BEFORE THE HEARING EXAMINER
CITY OF SEATTLE

Hearing Examiner Files:
MUP-19-019 (P) & MUP 19-020 (P)

Department References:
3032834-LU & 3032833-LU

REPLY in OPPOSITION to
APPLICANTS' AND OWNER'S
MOTIONS TO DISMISS LAND USE
APPEAL and for SUMMARY
JUDGEMENT

Figure 2 - 3410 23rd Ave W Application for Short Plat #3032833. The dashed line has been added to typically show an area required that is at least a 10-foot wide emergency access easement for the street to a lot with a dead-end alley.

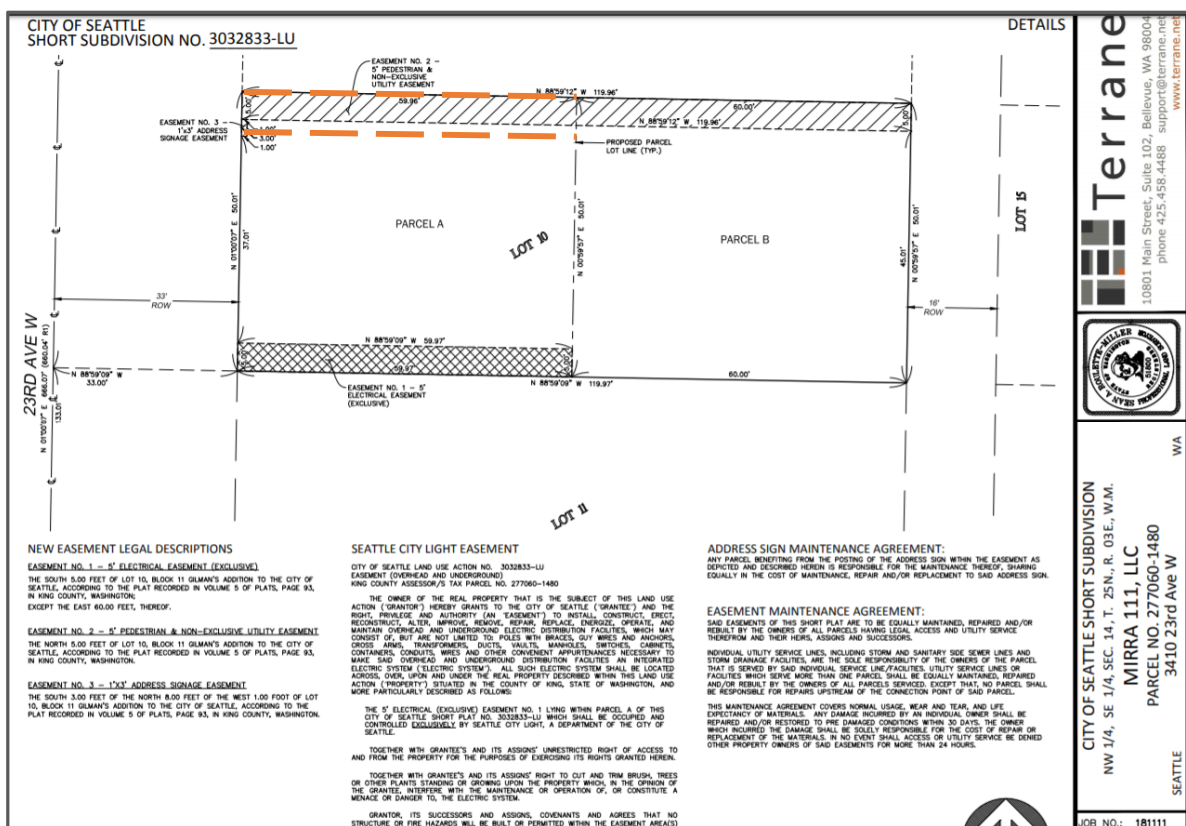
The note therein marked by “A” within the Rowhouse column rephrases the code requirement by stating “Each rowhouse directly faces the street with no other principal housing types behind the rowhouses.” As the Hearing Examiner can easily see within the Appeal Attachment “G”, the southern two of three adjacent developments included within this appeal includes a total of six (6) rowhouses

facing the street and four (4) other primary dwellings (townhouses) behind the rowhouses. If the six rowhouses were considered townhouses instead, then the total number of dwellings will exceed that allowed for the Subject Property's LR1-zoning.⁵ Refer to the declaration of Henry McGuire regarding Department responses to this issue of circumventing density limits with subdivisions. Also refer to the declaration of David Moehring, an architect considered as an expert witness in land use by the City Attorney and confirmed by Hearing Examiner Ryan Vancil within the appeal of the MHA FEIS.⁶

Figure 6 - Area interactive GIS map with larger and lighter-colored areas as Potential Slide Area - ECA2; and the smaller darker diagonally-hatched steep slope areas (ECA1).

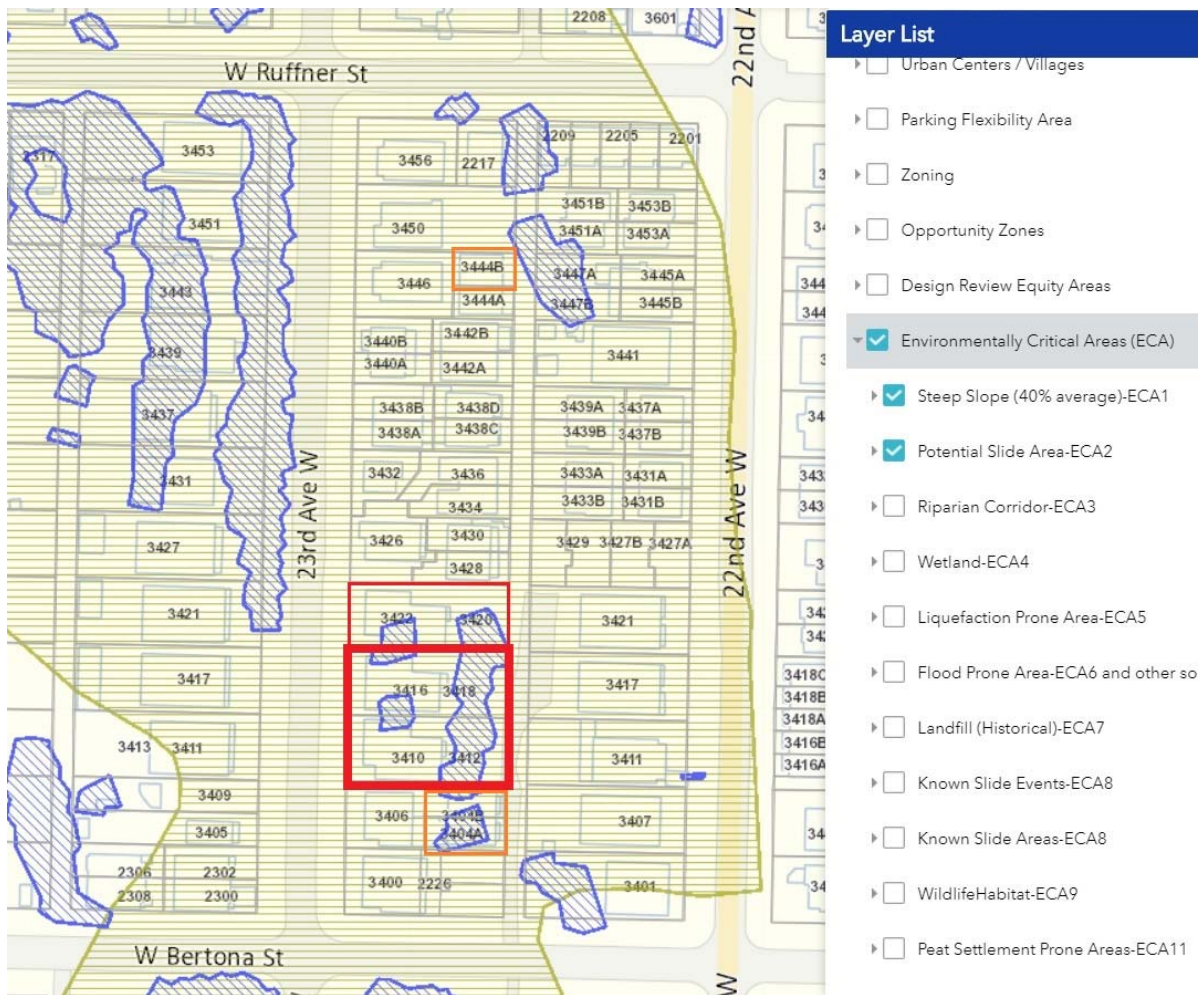
24 • **Decision is inadequate to Criteria 5:** The Department has failed to

Section 25.09.240, Short subdivisions and subdivisions, in environmentally critical areas. The assessment relative to this code section goes beyond the waiver of steep slope (or coded as ECA1). The appellants all live within Seattle's designated potential slide area (coded as ECA2). Each project within an ECA must complete 30-page ECA form for which the Department is to make an appealable discretionary decision on. This evaluation has not yet been completed. From the photos taken from the unimproved alley (found within the original Appeal Attachments) it is evident that the slope is substantial. The reason this is a concern on this subdivision

1 is that despite receiving the waiver of the steep slope, the decision criteria is bound
2 by the condition that the lower portion of the site is developed and that the soil is
3 stabilized prior to the upper portion. The motion to dismiss and summary judgement
4 excludes this consideration, nor does it provide the evidence that the imposed
5 condition is supported by the yet-to-be-completed SEPA evaluation. Therefore, the
6 Examiner does not have the authority at this time to consider dismissing this issue
7 without review of the facts. The Appellant has subpoenaed the City engineers for
8 this purpose (reference Figure 8 herein).

Figure 9- Geotechnical report cross section of development look from south to north.

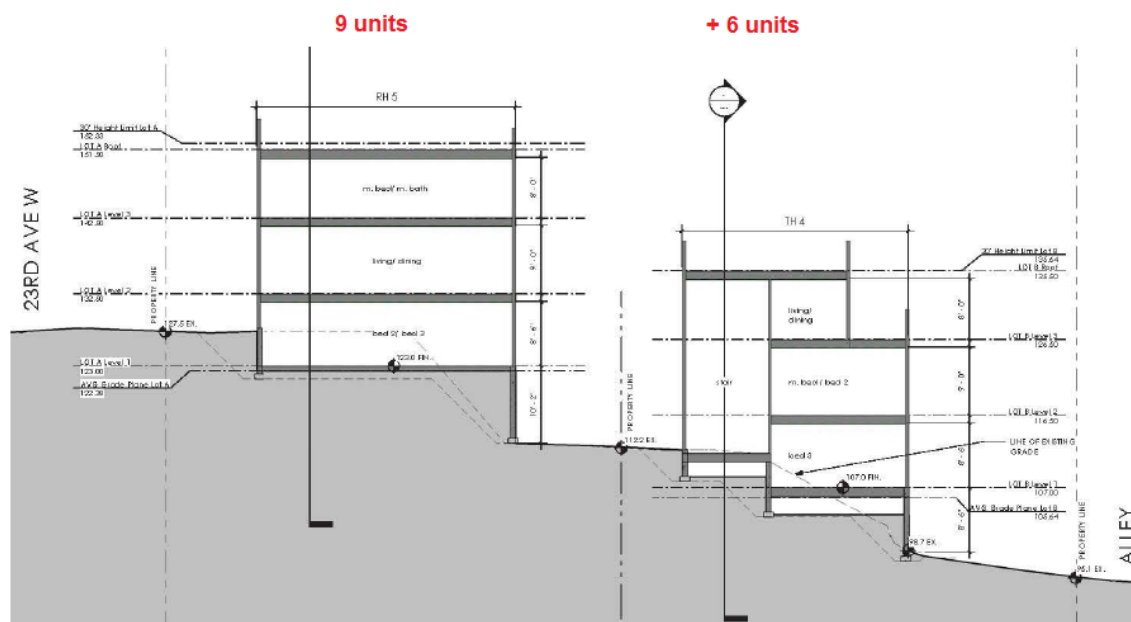
emergency access, legal lots, and impacts of the ECA to the SEPA evaluation. This case demonstrates all of those flaws and the Department's erroneous actions.
